To: Kathryn Espinoza, McKim & Creed
From: Brian Chambers, Assistant Director; 910.342.2782
CC: File;
Date: 5/13/2024
Re: Riverlights MX3 Townhomes TRC Rev 1

Project Name: Riverlights MX-3 Townhomes
Formal TRC Date: 5/16/2024
Reviewer: Eric Seidel, PE
Department: Engineering – Plan Review Section

Project Name: **RIVERLIGHTS MX3 TOWNHOUSES**

Project: Riverlights MX-3 Townhomes
TRC Meeting Date: 2/1/2024 ; 5/16/24
Reviewer: Anna Reh-Gingerich
Department: Stormwater

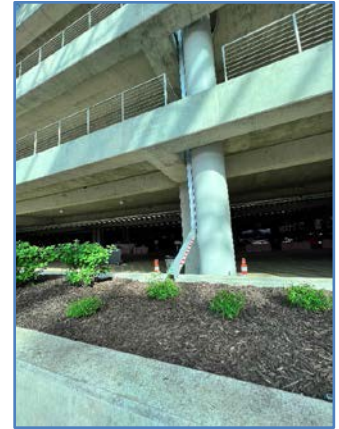
3. Consider green roofs, rainwater harvesting, or redirecting some downspouts from the buildings into stormwater planter boxes (as shown on the right) to help mitigate some of the roof runoff before draining to the drainage system:
